CITY OF NAPOLEON - BUILDING DEPARTMENT

Re: Driveway/Curb Cut 1801 Lamar Lane Napoleon, Ohio

Re: 1801 Lamar Lane Hoover Residence

CITY OF NAPOLEON 255 West Riverview Avc. Napoleon, Ohio 43545 419/592-4010 ADDENDUM TO PERMIT NO. 0/957

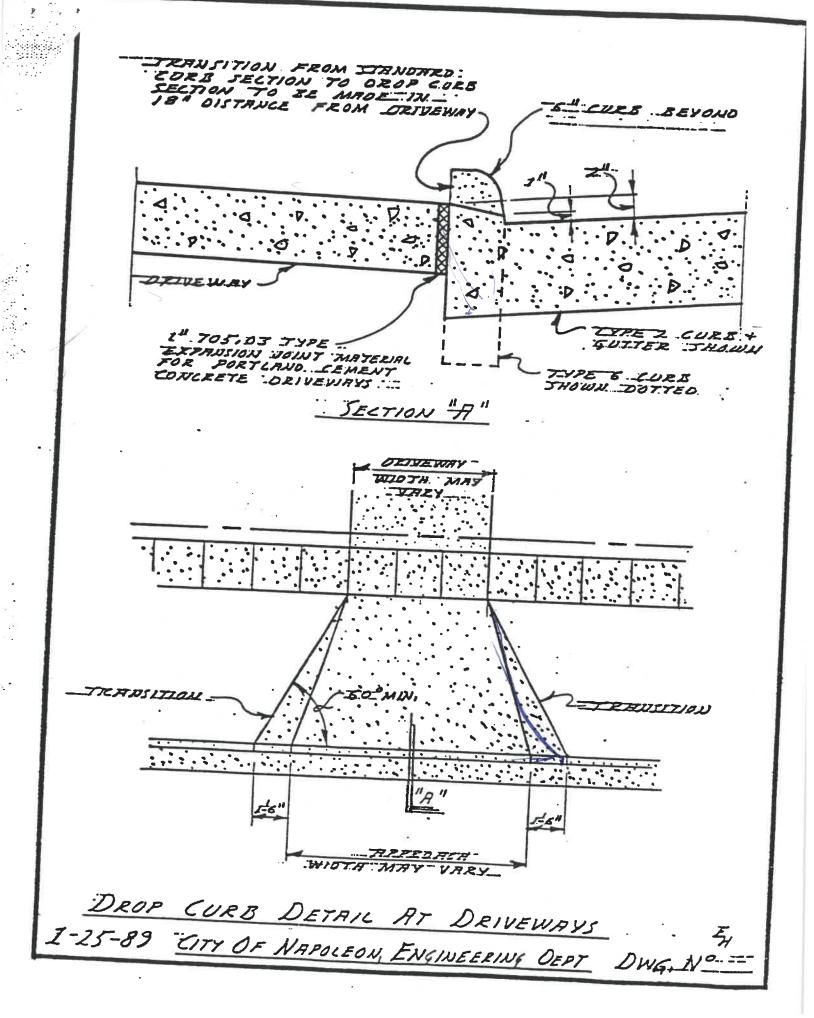
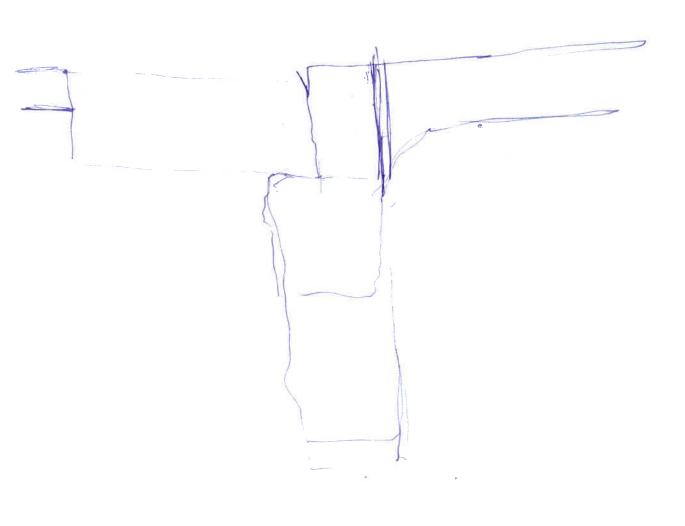
We have been notified by our Field Inspection Representative that your installation of the driveway and subsequent curb cut was not in compliance with our standard construction detail.

- Saw your driveway at the back of the curb line and install a new curb and expansion joint as per our detail (see attached).
- The City of Napoleon will have the curb cut and reinstalled and bill you the entire cost incurred.

Our concern over this matter is based on past history and documentation that the concrete will crack, spall off and eventually deteriorate prompting the Owner to place asphalt or concrete in the gutter line.
